REQUEST FOR INFORMATION (RFI)

Project No: 6515 Contract No: C-007 RFI No: 6515-C-230-007_003 Rev: 0
 Meliadine Project
 Site RFI Initiator: Matt Gallant Date: 2016-10-09

<u>Title(s):</u>	<u>Number:</u>	<u>Revision:</u>
D-CP1 Typical Sections and Quantities R1	65-685-230-208 R1	0
Geotechnical Specifications for Construction of Dike D-CP1 R0	6515-E-132-007-132-SPT-002_R0

Figure 1- Drawing 65-685-230-206

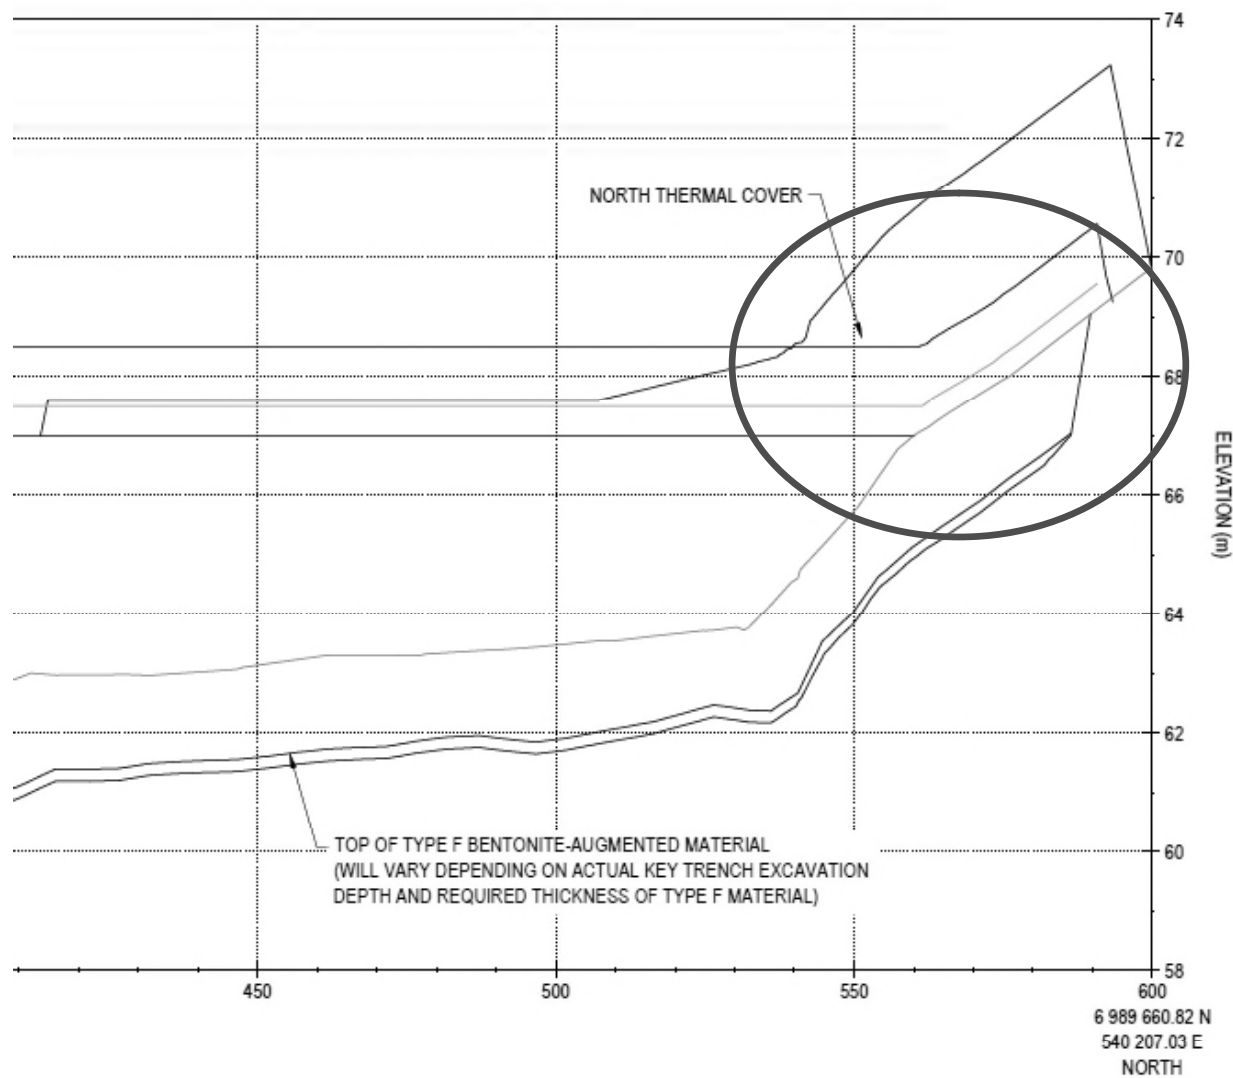
Please confirm that the top crest of the liner is meant to slope up from Elevation 67.5 m to 69.5 m at the North end of the dike (Station 1+560 to 1+590).

The contractor proposes to modify stations 1+560 to 1+590 and beyond to match the horizontal reflection of the design from stations 1+000 to 1+030, utilizing the intersection of the max, water elevation and the original ground as critical alignment points.

The reflected design would be inclusive of the key trench, thermal cover and all other associated information design.

There are major differences between the north abutment and the south abutment of D-CP1. The north abutment is on a small hill with relatively steep slope. We purposely designed to "over-excavate" the key trench further into the abutment to increase the seepage path for the north abutment. The dike south abutment is located on a flat ground on both the upstream and downstream sides; therefore, the natural seepage path is long so we do not need to extend. By the way, we have already reached the highest original ground location on the south end. In addition, we have limited space on the south end of the D-CP1 because there will be a haul road immediately on the south end.

In summary, we CANNOT adopt the south abutment dike design and use it for the north abutment design. They are different.

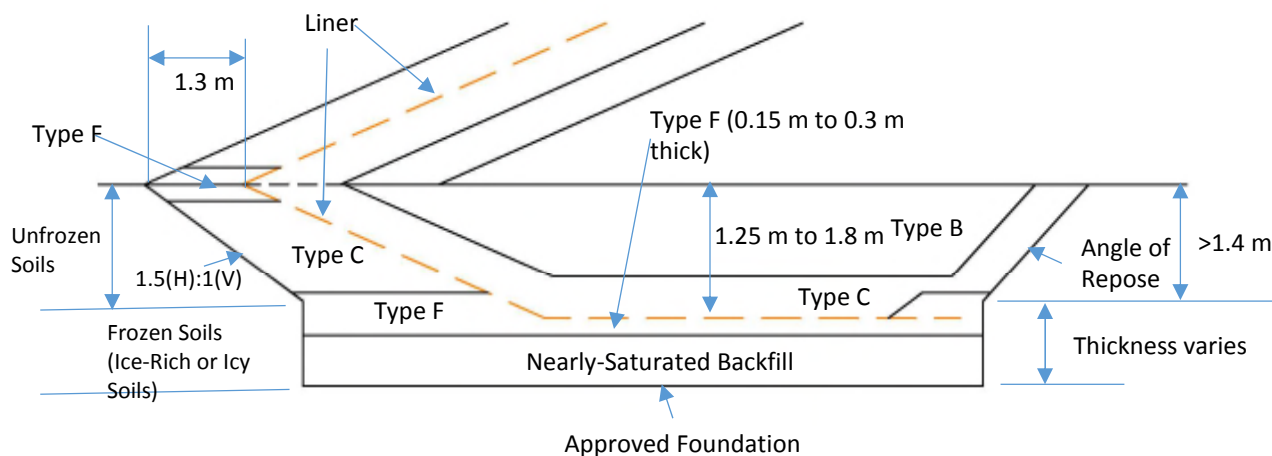
Proposed Solution:

We do NOT agree with the upstream side slope of 2.5(H):1(V) for the key trench that was proposed by the Contractor. This slope is too flat and is not consistent with the design intent.

- 1) 1.5(H):1(V) for upstream key trench side slope, which is the same as shown in the construction drawings; it is also acceptable if the upstream key trench side slope is slightly steeper than 1.5(H):1(V).
- 2) The actual "angle of repose" for the downstream key trench side slope, which is steeper than 1.5(H):1(V), as proposed by the Contractor.
- 3) Nearly vertical wall excavation below the toes of the upstream and downstream key trench slopes within the unfrozen active layer zone (1.4 to 1.8 m). This is generally consistent with the plan proposed by the Contractor.

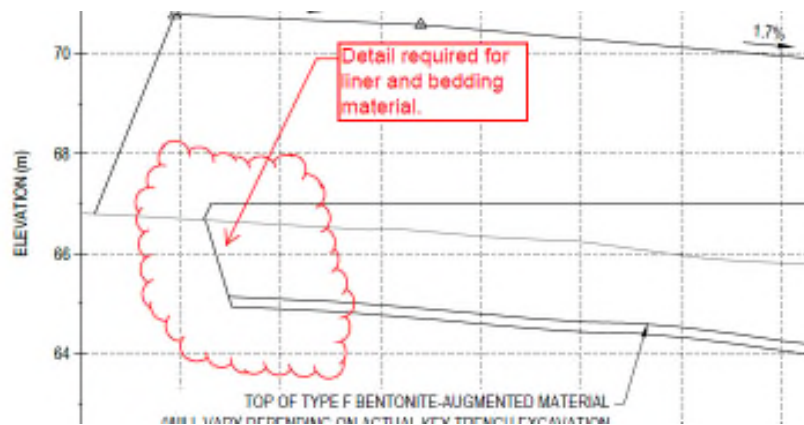
MTKSL is requesting tie in details for the termination points at either end of the key trench for DCP 1 and 5, more specifically related to requirements for the liner and bedding material in the area.

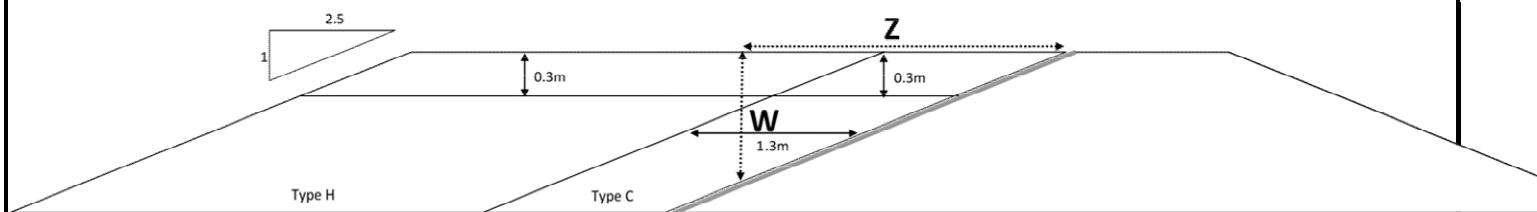
The contractor has concerns that packing the Type H material to the downstream edge (the point of contact with type C) as lifts are installed may result in damage to the Coletanche liner.

As the specified lift thickness of Type H is 300mm, the vertical distance from the liner at the downstream edge of the type H material is only 0.52 m. As Type H requires a minimum of 98% density the contractor believes that utilizing a 10 ton roller will be required.

Please clarify the minimum vertical distance (shown as W) below that is needed to be maintained from the 10 ton roller. This is turn will result in a horizontal offset (shown as Z) that will not be compacted by the roller. This zone will be compacted indirectly by the compaction of upper lifts.

2) Design changes for the option with lower Liner bottom elevation and no Type K material

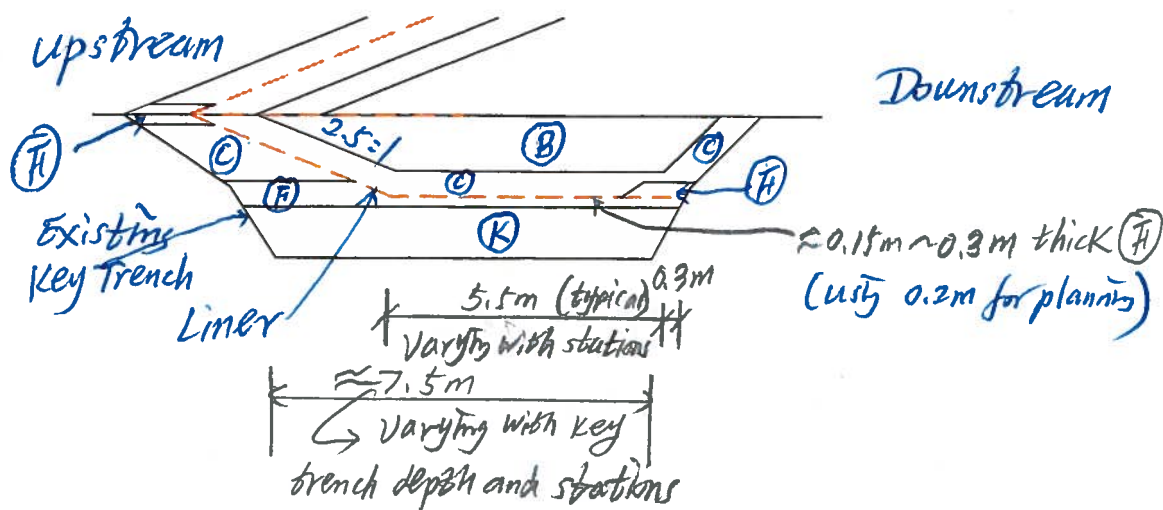
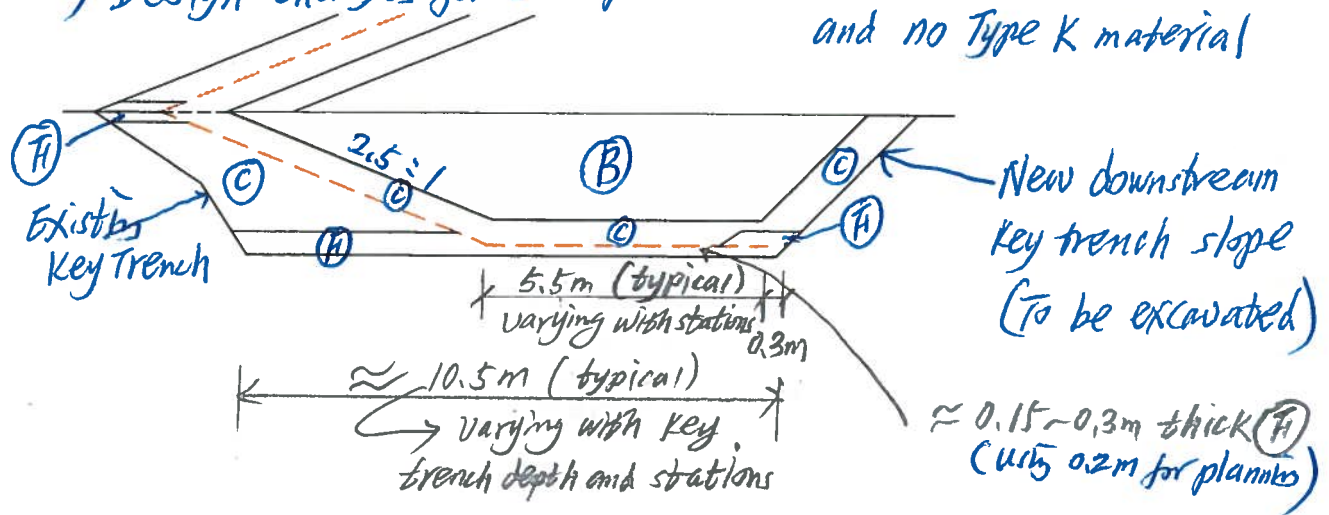
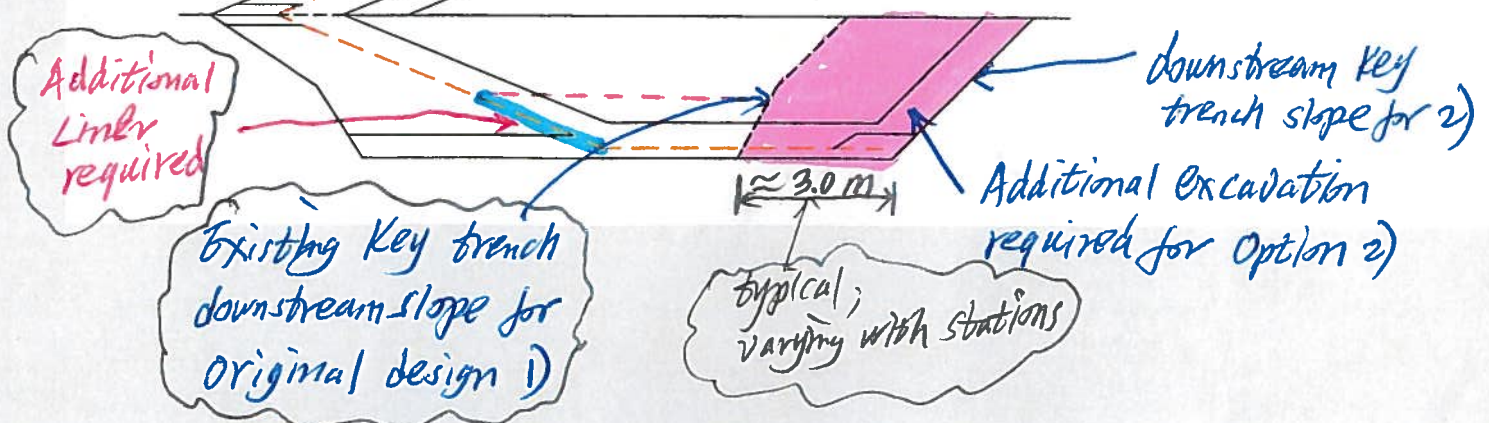
- Heating aggregate will not be possible until mid-February at the earliest using the on-site batch plant facilities.
 - Recommend placing 0.15 to 0.30 m thick Type F directly on base of key trench at the approved depths (approximately 2.8 m) and lowering the liner for remainder of D-CP1 from Stations 0+310 to 0+580 – all other overliner design elements will remain.

Based on the sketches (typical sections with 2.8 m key trench depth), the material quantity changes are roughly estimated for planning, assuming the changes for the option will be applied to Stations 0+310 to 0+580 (about 270 m):

The estimated quantity changes are provided for AEM's planning and decision making. The actual quantities will depend on the actual construction details and could be different.

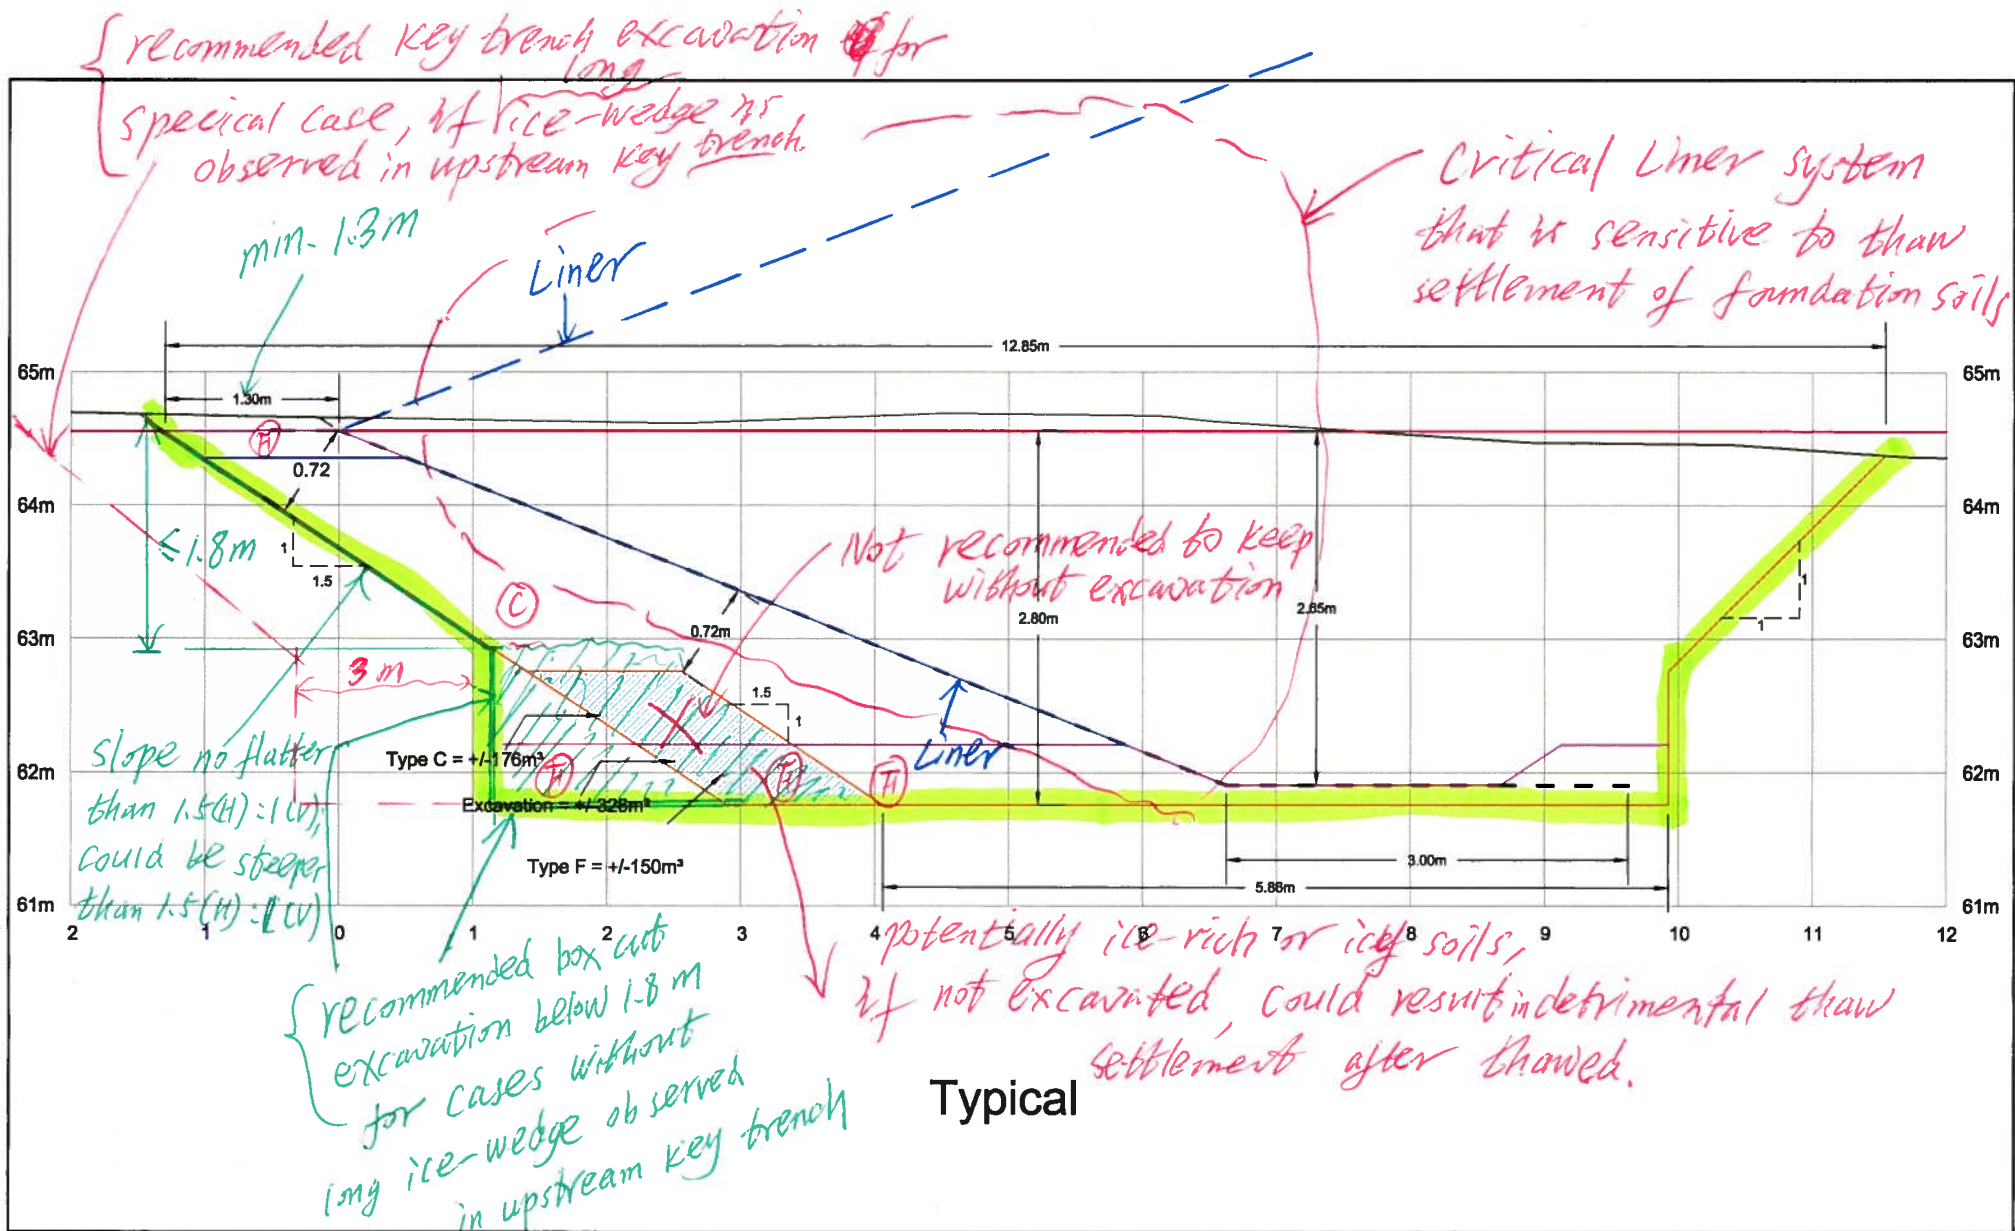
As an alternate option to reduce the excavation and Type F quantity MTKSL is proposing to use the existing minimum cover and slope parameters from the IFC design to create a step in the slope at the 1.8m elevation where the design key trench floor was planned to be encountered. (per attached detail) potential saving = 1.1m³/Ln.m of excavation and 0.5 m³/Ln.m Type F.

Technically, we do not recommend the key trench excavation option that was proposed by MTKSL in this RFI for the following reasons:

Based on MTKSL's original sketch, notes are made in the attached sketch to show the recommended excavation plan for the case with a required key trench depth of up to 2.8 m.

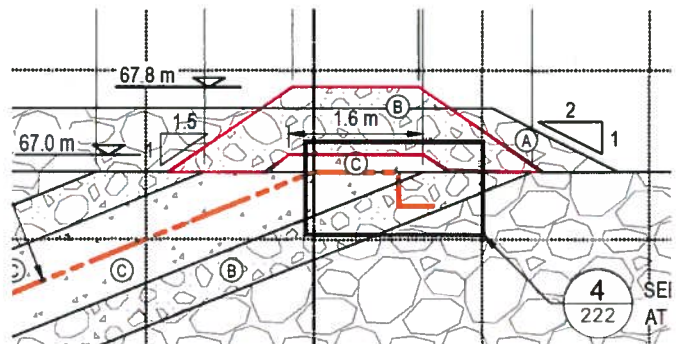
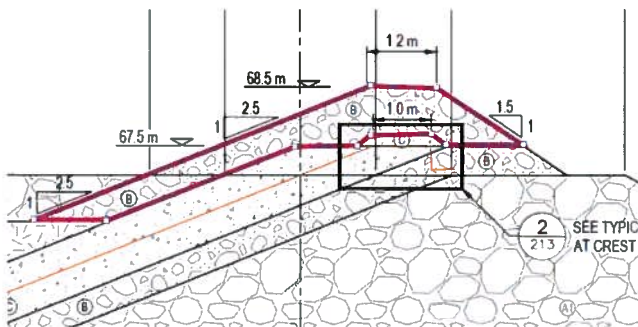
Based on survey data and approved design changes MTKSL has calculated the neat line volume of Type B to be 16,191 m³. This volume considers D-CP1 to be constructed with no substitutions where Type B is required (including the additional excavation) and D-CP5 to maintain Type B as per design above OG and a minimum thickness of 300mm from OG down within the Key Trench. The remainder of D-CP5 Key Trench Type B will be substituted with Type H.

1. Replace the Type B material within the very top cover portion of the Dikes with Type B material produced from UG ROM as this location is already adjacent to Type A material. (see below)
2. Replace the Type B material within the very top cover portion of the Dikes with the 0-125mm Type H (see below)
3. Produce an additional quantity of clean Type B from the A1 supply which is not ideal as the quantities are already tight for this material.

Option 2 to replace Type B with Type H (esker sand and gravel) has two issues. The esker sand and gravel (Type H) is susceptible to surface erosion and therefore, is not a suitable material to be placed over the dike crest. Secondly, the majority of Type H required for construction of D-CP1 has not been produced at this stage. The availability of additional, qualified Type H is uncertain.
